(Draft) EMS's views against JAPC's claim concerning the fault evaluations of Tsuruga PS site, EMS on shatter zones in the site of Tsuruga Power Station		JAPC's opinion	Reference No.
Main texts	Issues		
<p><EMS's views on the claim 2> The evaluation report states that the K fault is 'the structure which continues to the D-1 shatter zone'. The reasons are as follows;</p> <p>(1) As stated in the 'Claim 1', the specialist of geology pointed out as follows, concerning the thin section observations implemented for the G fault and the D-1 shatter zone; - (Skipped) In this way, EMS considers that <u>the evaluation of displacements are not reliable and provides insufficient evidence for the claim that there is no connection between the K fault and the D-1 shatter zone.</u></p>	Same as the Claim 1.	Same as our view on the Claim 1 in the EMS.	—
<p>(2) Especially, the point where the strike of the K fault is bent to the NNW – SSE direction* was <u>recognized mainly in the deposits above the bedrock</u>. In general, the strikes and dips of the faults found in deposits are not constant and they could vary from place to place. Therefore, <u>it is not possible to conclude that the K fault does not

Survey on continuity of K fault 2-1 pit

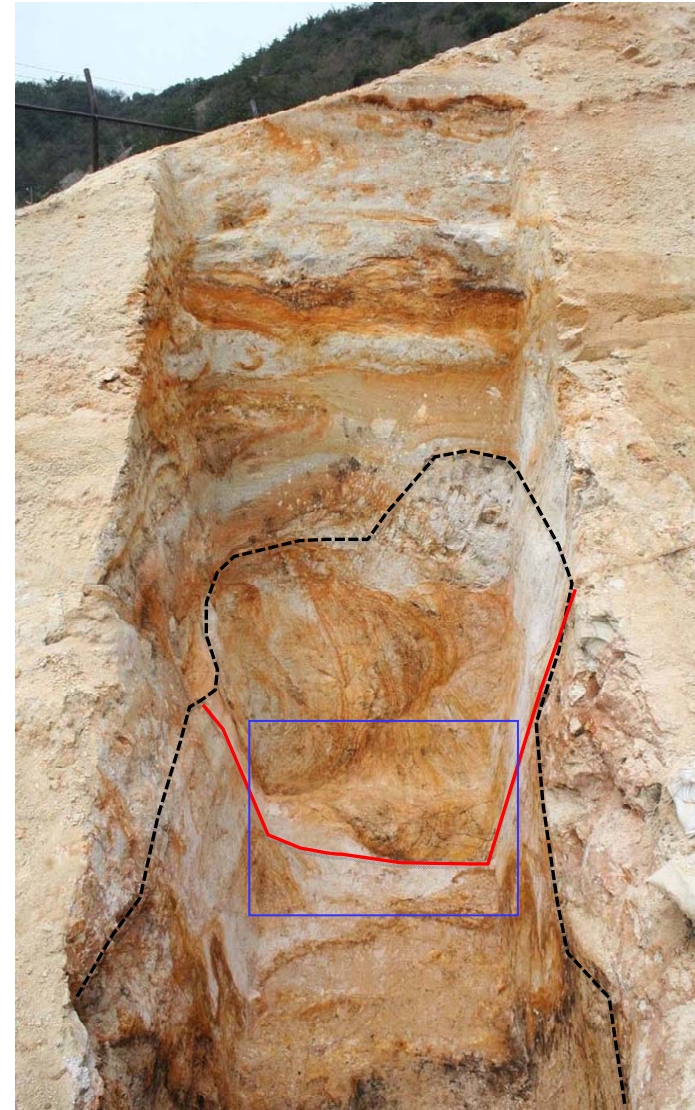
• At D-1 trench, 2-1 and 1-1 pit surveys have been carried out in order to clarify the characteristics, strike, and dip within the basement of the K fault.

- It is confirmed that the K fault strike is a direction of N-S within the basement based on the result of 2-1pit boring in the side of L-cut pit of D-1 trench.

Survey on continuity of the K fault Northern widening of western pit

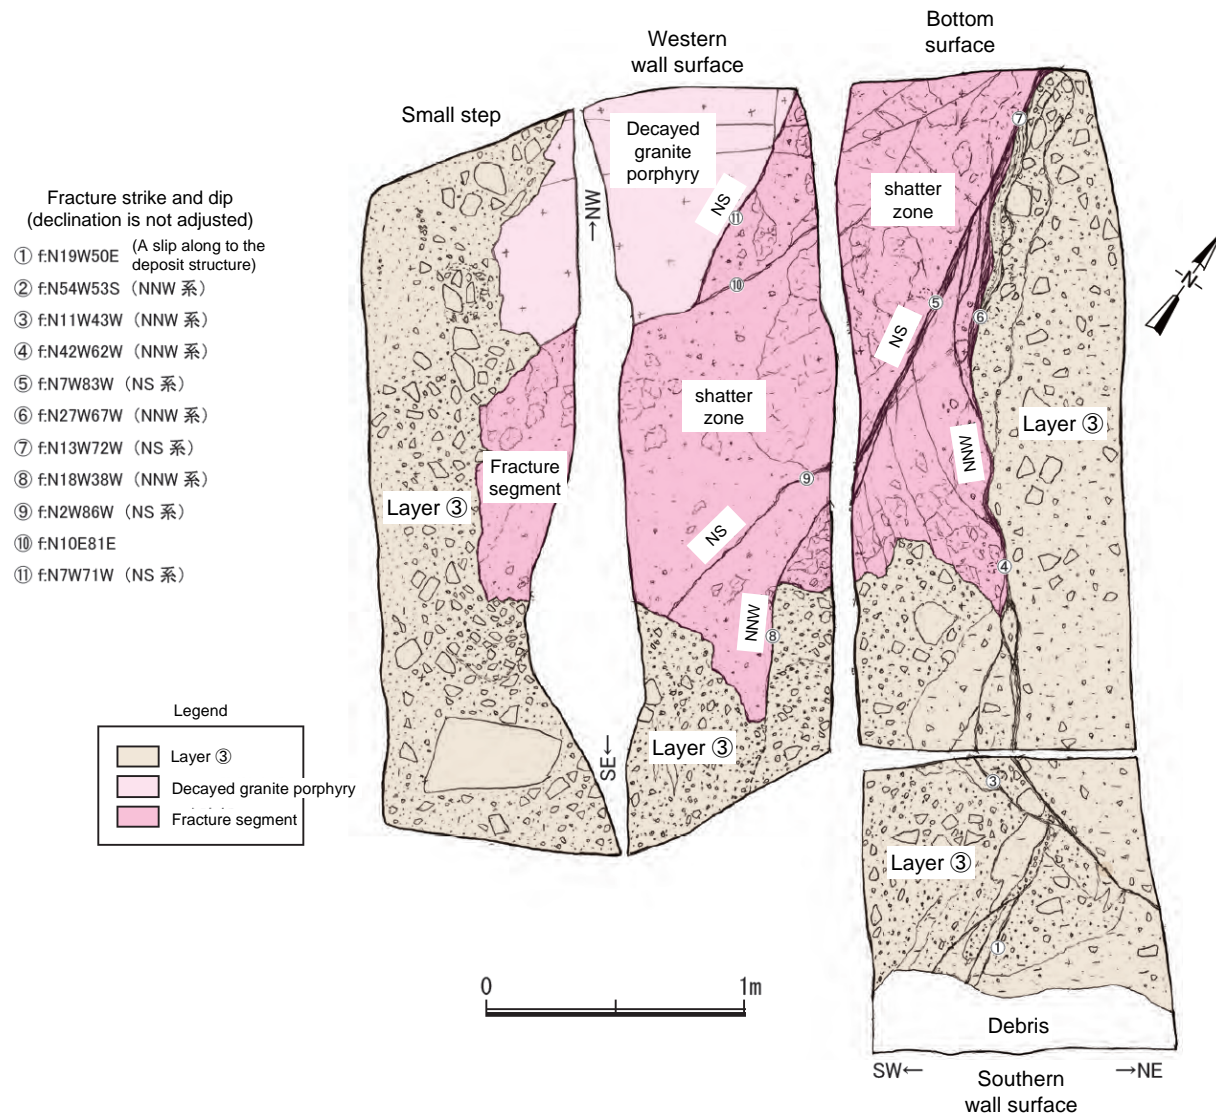
- The shatter zones running to the directions of N-S and NNW-SSW are recognized in the basement rock at the northern widening of western pit.
- The K fault, which displaces and deforms layer ③, has changed its strike directions from N-S to NNW-SSW in the western pit.
- The fracture segment with N-S direction strike does not displace and deform layer ③ in the south part from the bend.

Survey on continuity of the K fault 1-1pit (advance report)

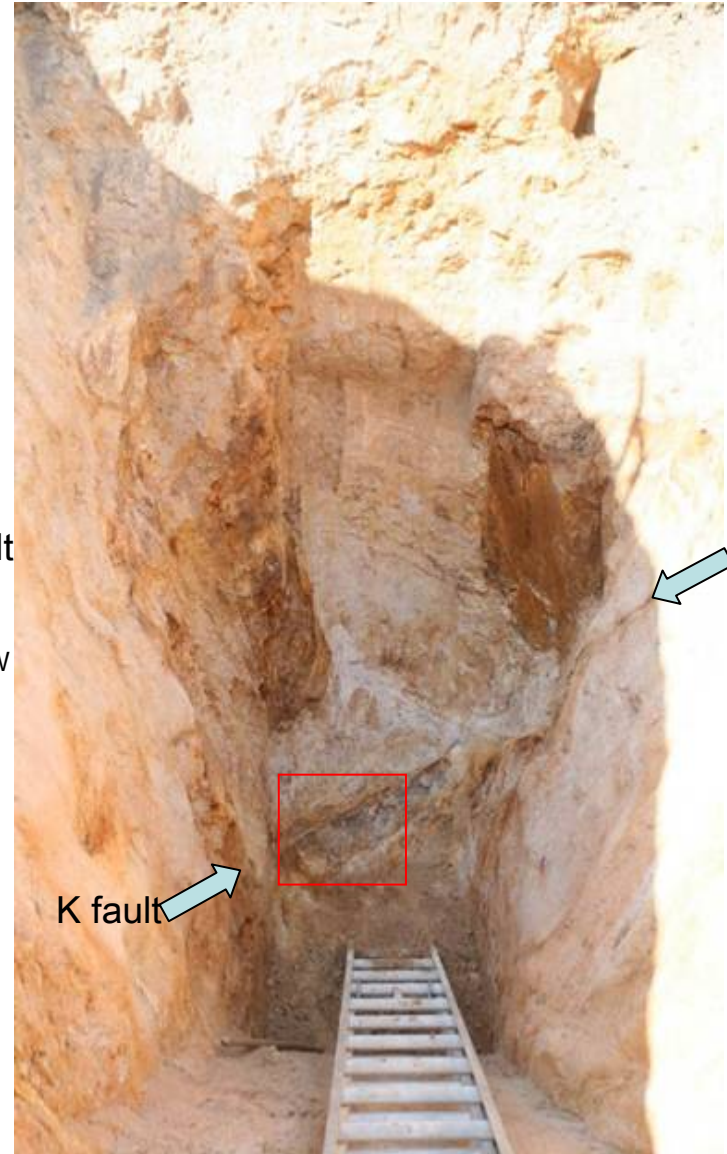
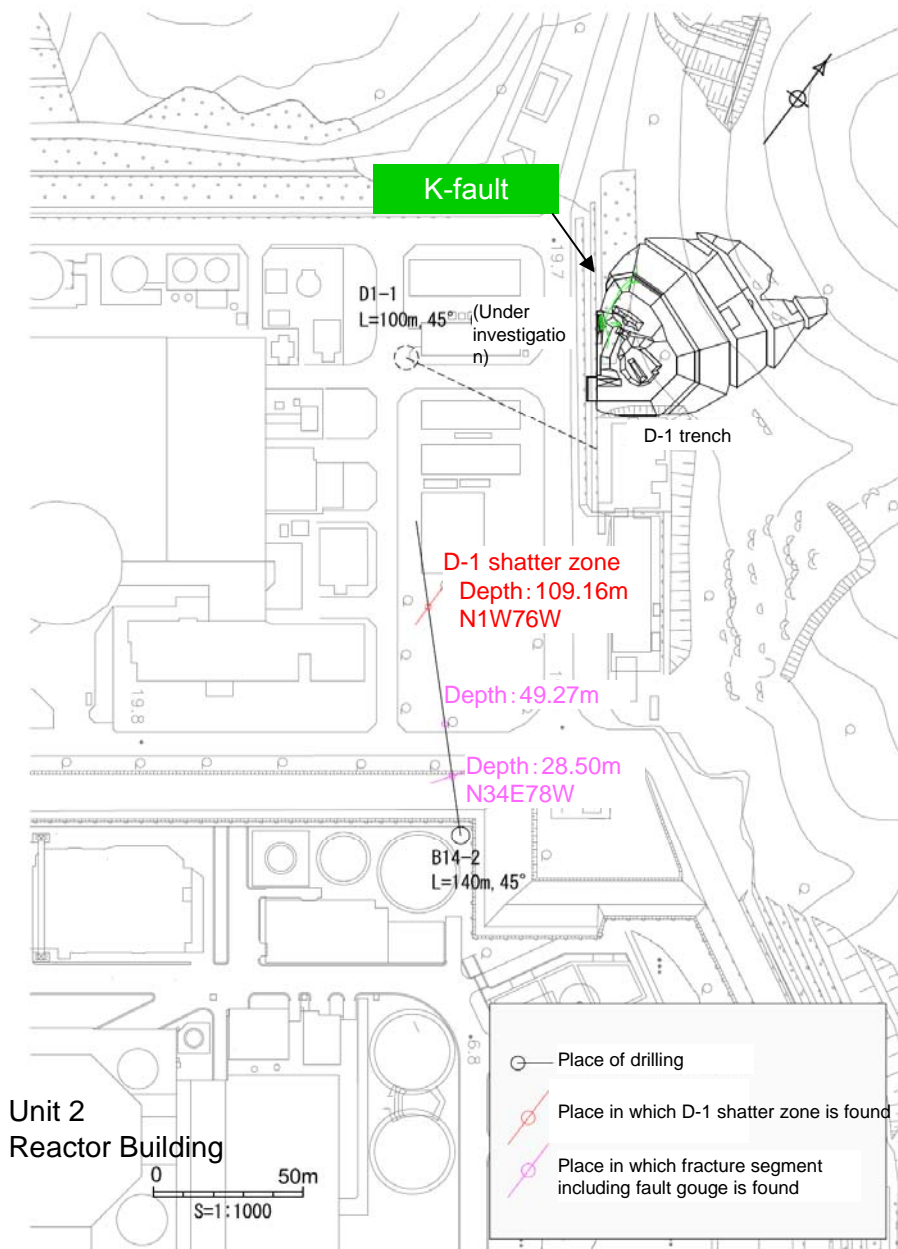
- In the result of 1-1pit boring in the south of western pit of D-1 trench, K fault indicate NW-SE strike in the basement. It is confirmed that the K fault does not extend to the direction of Unit 2 reactor building.

Discussion about the K-fault's extension to the southward

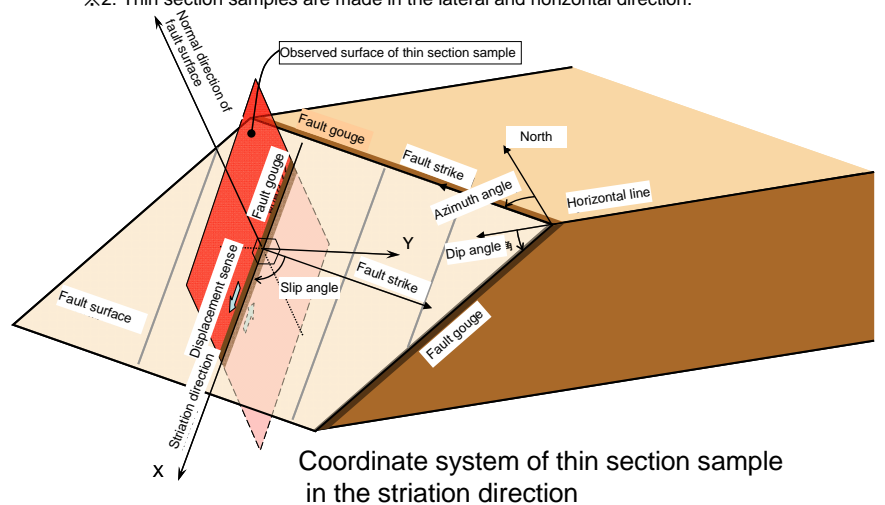
- Three fracture segments with fault gouge have been found at B14-2 drilling, that cross the line between Unit 2 reactor building and K-fault.
- Displacement sense of the last slip has normal fault sense at each fracture segments.

- K-fault, that has reverse fault sense, does not extend to the southward from at least B14-2 drilling place.
- ※To obtain the additional data, drilling at D1-1 is undergoing.
